BOWLES & WYER

The Hoo

MMA Application Landscape
Planning Report_Rev A

2658

3.0 Proposed adjustments

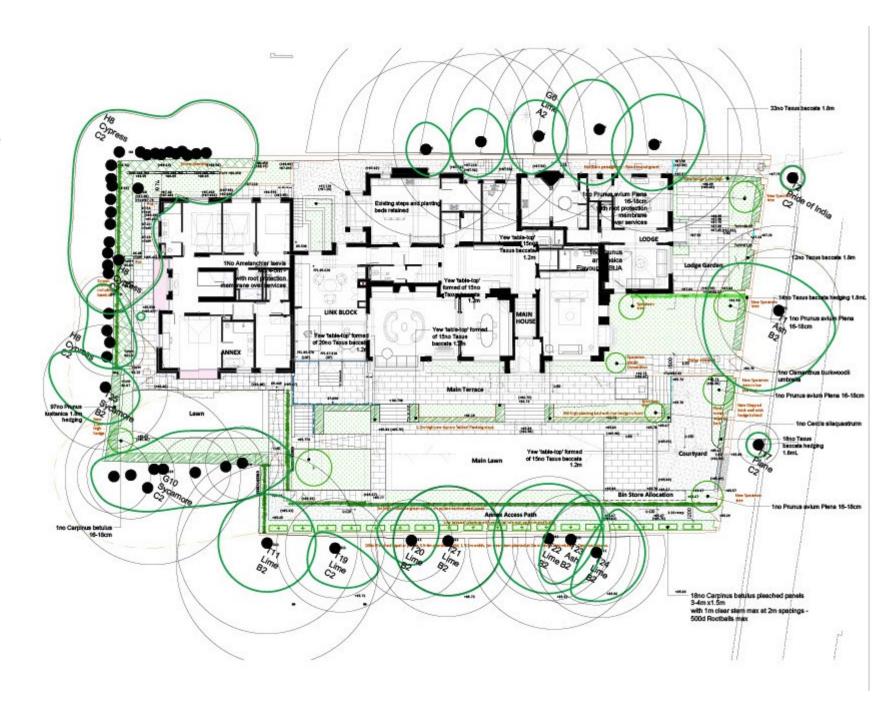
The revised proposals aim to retain, or increase where possible, the soft landscaping against the consented scheme 2019/6151/P.

The bulk of the adjustments are a reaction to the change in building outline. The changes do not result in any further loss of existing trees with further tree planting proposed for the southern boundary. We feel the proposals maintain a high-quality landscape which contributes to the visual amenity of the area.

4.1 Lodge garden

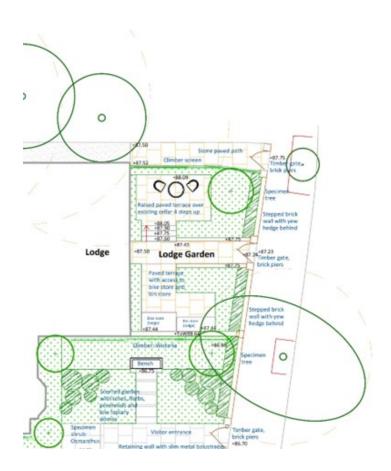
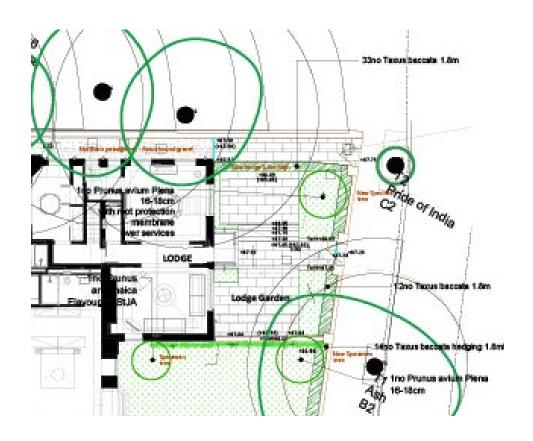
Minor adjustments made to accommodate the building outline change. Paving arrangement within the Lodge Garden has been adjustment to suit with an overall increase in soft landscaping.

4.2 Main terrace/lawn

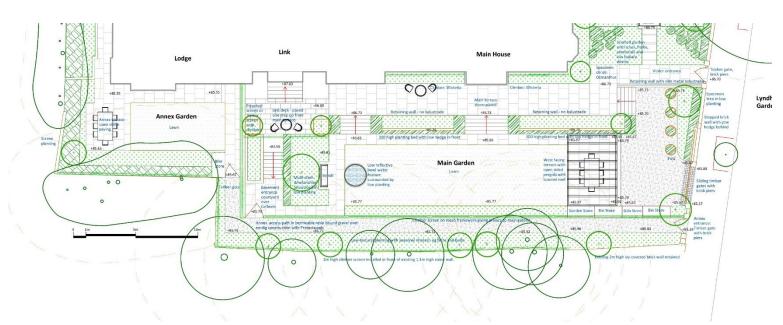
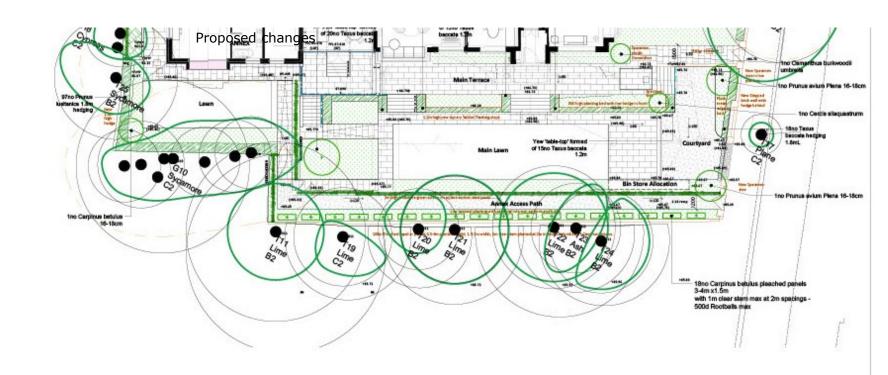
Paved area removed and replaced with a longer lawn, increasing the soft landscape in this area.

Adjustment made to accommodate access to the lower ground floor Annex. Overall increase in soft landscaping in the area.

Proposed pleached trees introduced to southern boundary to increase the overall proposed tree planting compared to the consented scheme.

4.3 Back of house

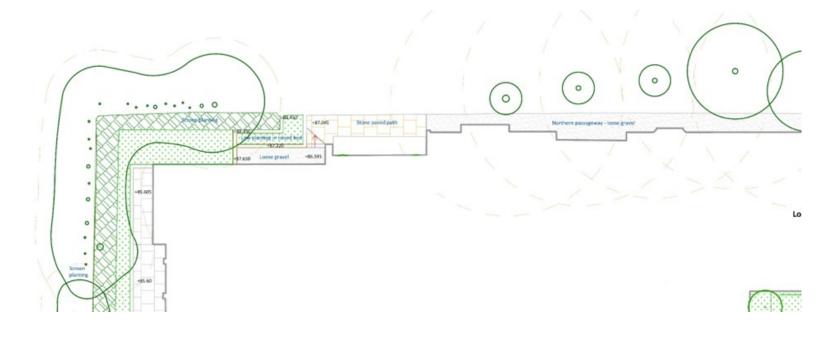
Retention of existing staircase and tiered planting bed and minor adjustment associated with change in building outline.
